**RENOVATION OF THE KHANDEK
INTERMEDIATE SCHOOL
UNDER THE ECONOMIC SUPPORT FUND PROGRAM
YOUSEFIYA, IRAQ**

SUSTAINMENT ASSESSMENT

**SIGIR PA-08-136
APRIL 21, 2009**

Figure 2. Septic tank section (Courtesy of GRC)

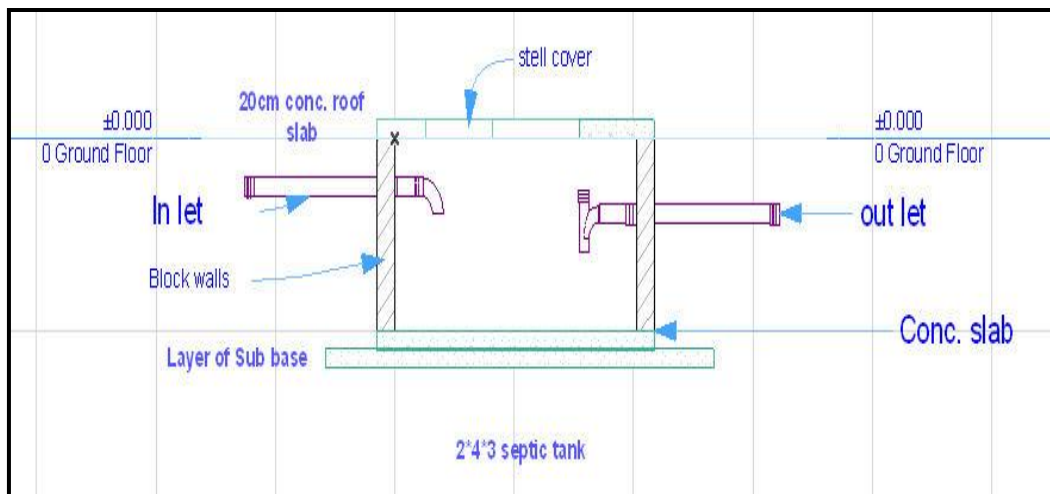
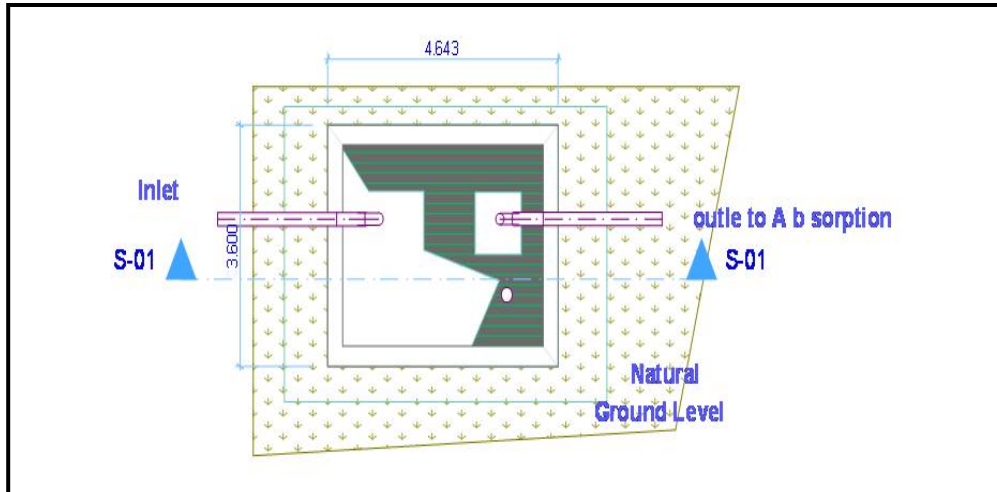
The septic holding tank indicates that the outlet of the tank flows to an absorption area. The location and configuration of the absorption was not indicated in the design. It is unclear if this system is intended to treat sewage and promote absorption into the soil, or if the tank(s) function as holding tanks to be pumped out on a regular basis.

Site Photo 6. Missing window screen

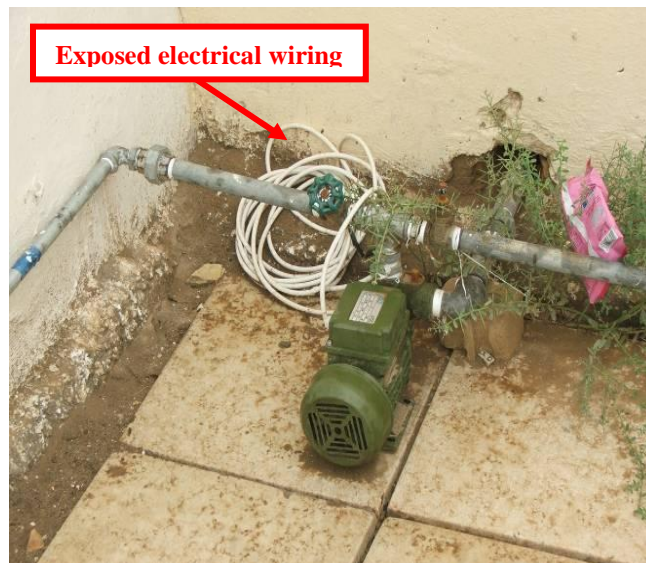
The new steel exterior doors and hardware were installed and functioning. The window glazing appeared to be in-tact. The windows have been painted and latching hardware has been installed. SIGIR did not observe any of the BOQ required window screens (Site Photo 6).

1. Ensure that the cracking and deflection of the reinforced concrete beam along the front of the new restroom facility does not present a safety hazard.
2. Anchor the water-supply pump to a support and enclose wiring to the potable water-supply pump in conduit.
3. Provide the window screens required in the contract.

Site Photo 8. New latrine building with significant shear crack

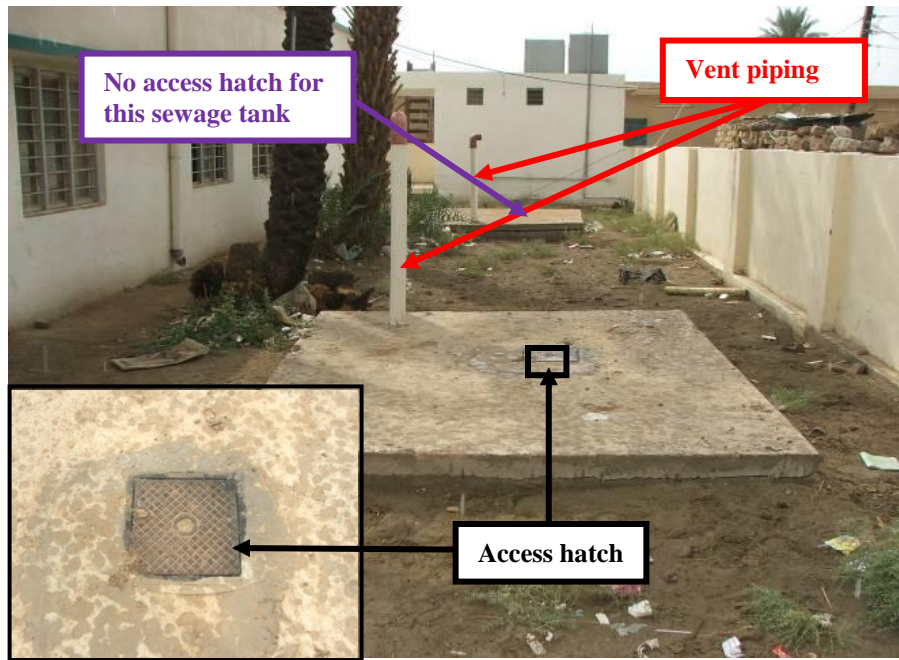
A new septic tank was constructed along with the new latrine. SIGIR identified a significant shear crack in the main beam along the front edge of the roof on the new latrine building (Site Photo 8).

SIGIR does not believe the contractor's "fix" is adequate. The depth of the crack needs to be determined in order to identify the most appropriate correction.

Concur with all recommendations. The Gulf Region Central will require the contractor to take the actions outlined in the recommendations.

Site Photo 10. Septic holding tanks and tank access for one (lower left corner)

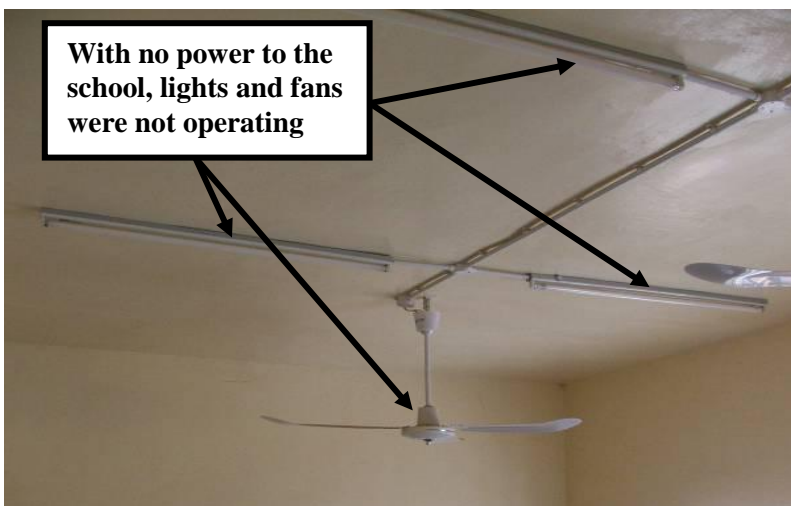
Two septic tanks were constructed on the site to service the two latrines (Site Photo 10). Vent piping was installed in the top slab of the tanks. SIGIR examined the tanks' top slabs, which did not exhibit any cracking or signs of failure; however, there was moderate curling of the top slab. A small access was provided for one of the tanks, which could be used for inspection and pumping; however, there was no access provided for the second tank. SIGIR believes this presents the school with future maintenance problems, since the school will be unable to fully empty the tank and residue will accumulate at the tank's bottom.

The contractor agreed to install an access hatch for the new sewage tank. GRC representatives verified that the contractor did install an access hatch (Site Photo 14). This access hatch will allow the school to periodically empty the tank so that residue will not accumulate at the tank's bottom.

Figure 4. Contractor's site plan submittal clearly showing the construction of a new water closet (latrine building) (Courtesy of GRC)

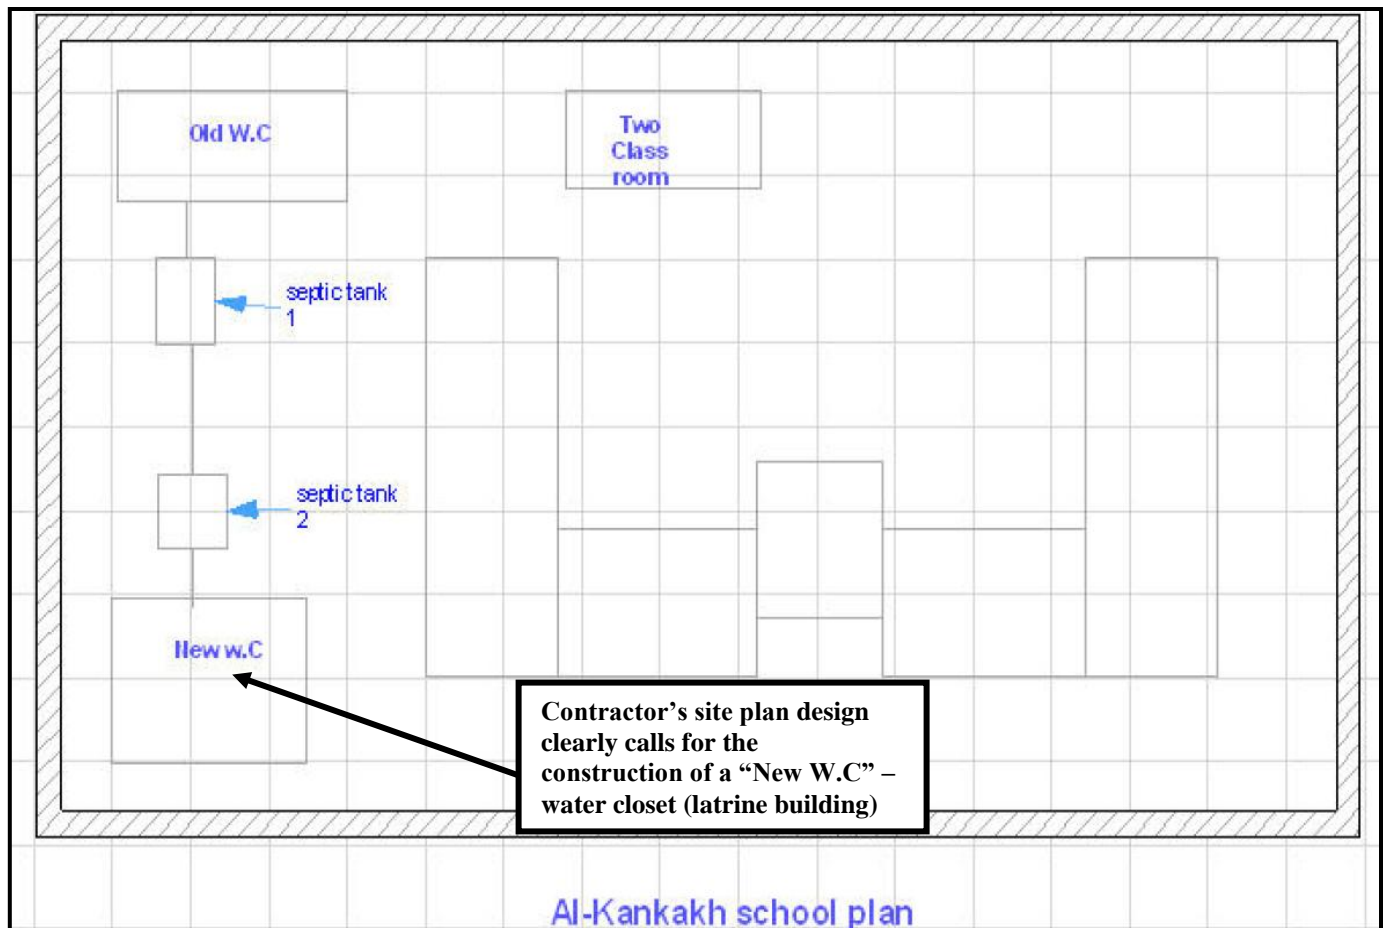
However, this statement is contradicted by the contractor's design submittals, which clearly indicated on the school's site plan "New W.C. [water closet]" (Figure 4). The design, which the contractor submitted to GRC for review and approval prior to construction, refutes the statement that this water closet/latrine building was the idea of the school master and not part of this contract.
